From: [Stephen Ubl](#)
To: [Marcia Moermond](#)
Cc: [Nathan Bruhn](#)
Subject: FW: 733 Fairview Ave. N.
Date: Monday, March 11, 2024 1:04:54 PM
Attachments: [image005.png](#)
[image006.png](#)
[image007.png](#)
[image008.png](#)
[image009.png](#)
[image010.png](#)

I have been told that you are engaged in a project at 733 Fairview Ave. N., a building identified as a Vacant Building Category III. If you have questions regarding Plan Review, Permitting, Inspections, or Appeals, please reach out to me and I can see what I can do to move this project along.

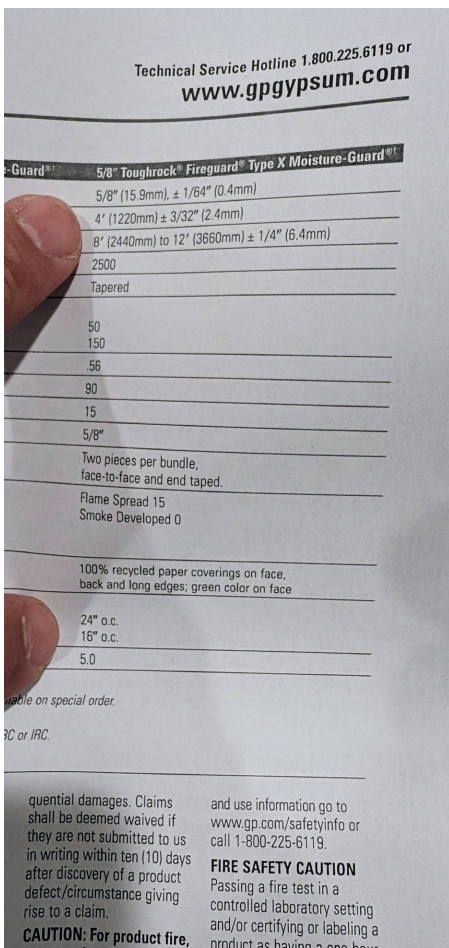
To this end, as illustrated in the Georgia-Pacific manufacturer's installation recommendation instructions for the 5/8" Toughrock Fireguard ("green" board) Type X Moisture Guard gypsum sheetrock that has been installed in the 733 basement ceilings, Framing Spacing, Maximum for Ceilings is **16" o.c., not 12" o.c.**

To this end, the basement 5/8" ceilings at the 733 Fairview Ave. N. property remain in compliance with both the CertainTeed ("purple" board) and the Georgia-Pacific ("green" board) manufacturer's installation recommendations of a minimum of 16" o.c.

Below is an email from the owner. The information provided by him does not reflect the material installed in the home at 733 Fairview Ave N. My inspectors took the time to go to Menard's and communicate with his contact, retrieve the correct material information, and affirm that the correct material in the home was installed per manufacture's recommendations.

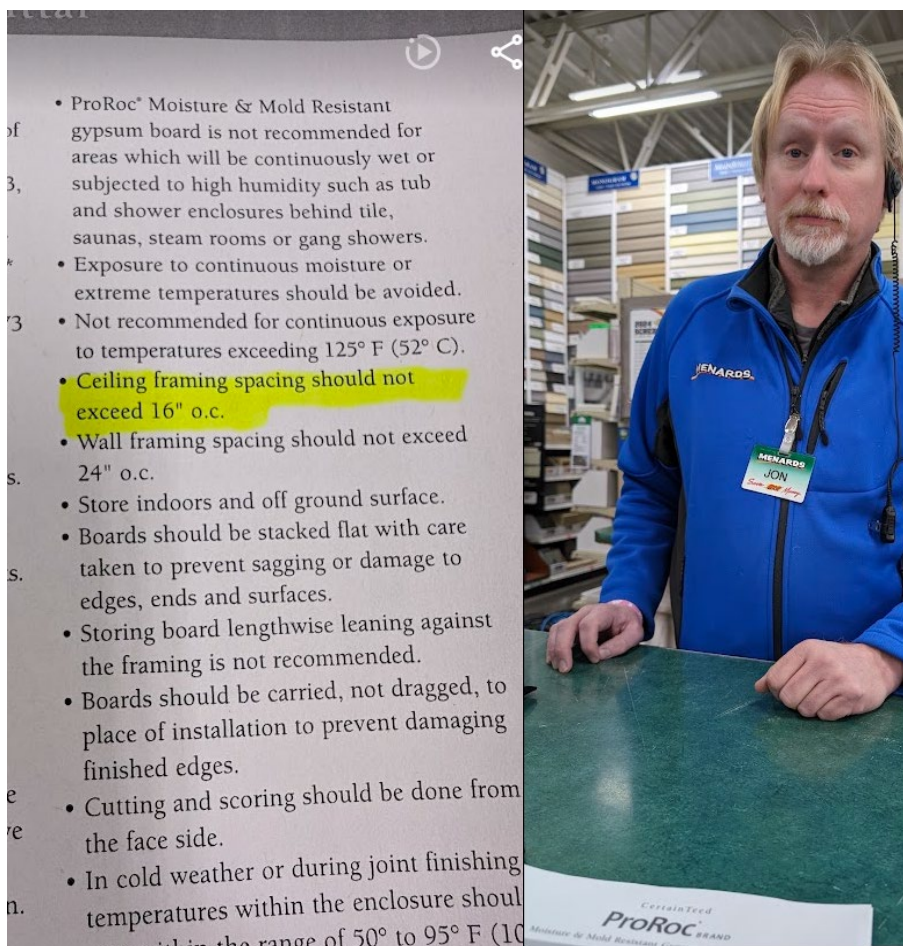
Tuesday, after our meeting, I went to Menards. I eventually was able to speak with Jon, in the building center, who is familiar with my situation. I asked him to provide me with the literature on the manufacturer's installation instructions for the moisture-mold-resistant sheetrock to determine whether what I did in my home complied with the manufacturer's installation recommendations. I asked him specifically whether the moisture & mold resistance gypsum board he sold me from Menards to install on many of the walls and ceilings, per the manufacturer's instructions, called for it to be installed on 16" on center or whether it required a lesser distance. Without saying a word, Jon got on his screen, printed, and with his yellow highlighter, marked the following and slid the paper over to me: **"Ceiling framing spacing**

should not exceed 16" o.c." Based on the above, I complied with the manufacturer's gypsum board moisture-mold-resistant installation recommendations, Stephen.
